Geotechnical Review of the Quarry Backfilling, Kinley Estate, Lilydale

16 December 2020

Geotechnical Review of the Quarry Backfilling, Kinley Estate, Lilydale

Figure 5-1: % Hydro-consolidation and initial void ratio

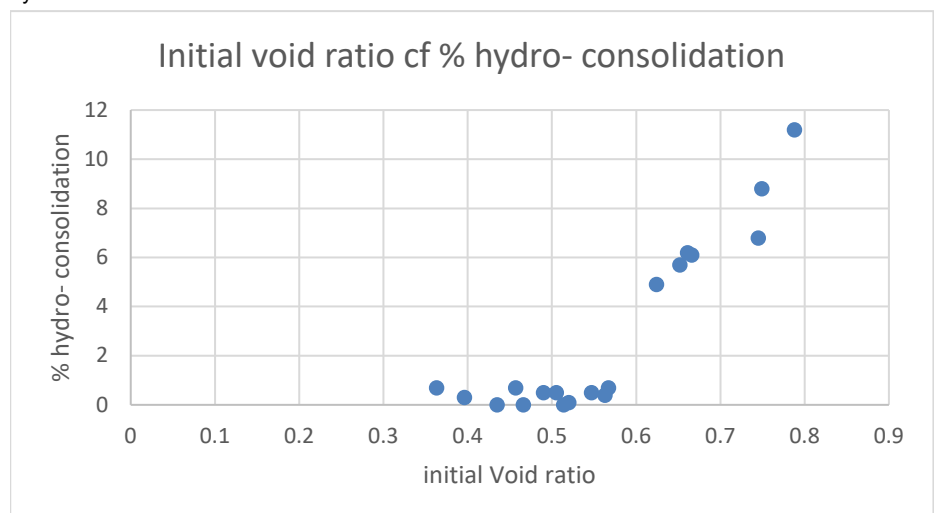
5	Upper Fill material	It is desirable to have low reactive material in the upper 2.5m or so of the fill material to reduce soil reactivity. It is recommended that low reactive suitable soils of not greater than 75mm in diameter in the upper 2.5m of fill be adopted.
5	Fill Suitability	We agree with all parties that organic matter, topsoil, pure silt, acid sulfate soils, contaminated soils and foreign matter are not suitable. The environmental suitability of the soils is not part of this assessment but could be provided if required. While the max particle size is limited to 300mm, limits on the % of oversized material and any gap grading must be undertaken to avoid voids occurring between boulders, not just a limit on size, and a visual assessment is recommended by Golder and we agree with the recommendation that the specification should contain a limit of coarse rock per m ³ .
5	Moisture Conditioning and Relative compaction	T & T argues that limits on the moisture placement is not required based on their testing. T & T propose to compact the fill materials, presumably at the field moisture content that is well dry of the OMC. We understand that this will make higher levels of relative compaction possible but considerable effort may be required by the contractor. The test results show that the level of compaction is the more important factor in reducing the hydro-consolidation than the moisture content, but the air void ratio is a combination of both of these factors. Using the results of the consolidation tests undertaken by T & T and notwithstanding some of the anomalies in the test data, the test results indicate a clear relationship between the initial void ratio (or relative compaction) with % collapse for a particular stress. If the initial void ratio is below 0.6, the % hydro-consolidation is below 1%.

Figure 5-2: Dry Density ratio compared with % hydro-consolidation

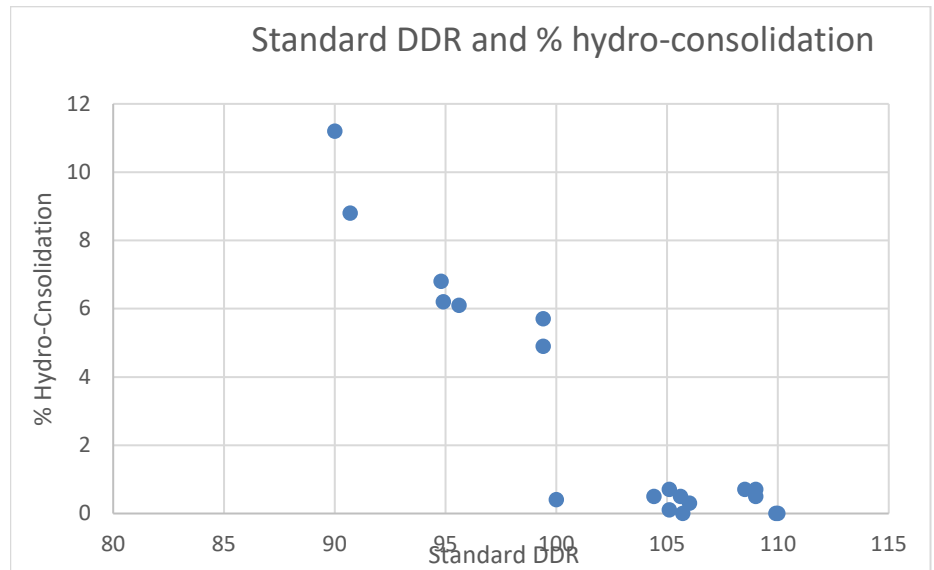
Expressed in another way, if the Standard DDR is equal to or greater than 101%, the collapse consolidation is less than 1% as the void ratio has been sufficient reduced. It is noted that a minimum average Standard DDR of 101% is specified for the filling of the quarry, but the minimum of 98% SDDR could undergo some greater hydro-consolidation.

Based on the T & T data, there is no direct relationship between moisture content alone dry of the OMC and the % collapse consolidation. A change in the density of the soil will have a bigger effect than a change in the moisture content. For example, a 10% change in the density will have a much bigger effect than a 10% change in the moisture content in reducing the void ratio. However, the literature indicates that % hydro-consolidation is expected to become greater as the moisture content becomes more dry of the OMC for the same DDR. (Waddell & Wong, 2005).

We agree with Golder comments about the need to avoid placing the material too dry of the OMC as it will create a higher air void ratio for the same DDR and the potential for greater future hydro-consolidation settlement. We also note that the placement of material too wet may mean that the DDR cannot be achieved and lead to saturation of the compacted clays. Porewater pressure dissipation is then occur as the fill becomes more loaded. However, it is noted that the higher compaction even if dry of the OMC can also reduce the air void ratio to an acceptable level.

As recommended by Golder, a target moisture limit should be specified for the specified DDR but can be fairly broad and it is acknowledged that the DDR is the more important factor.
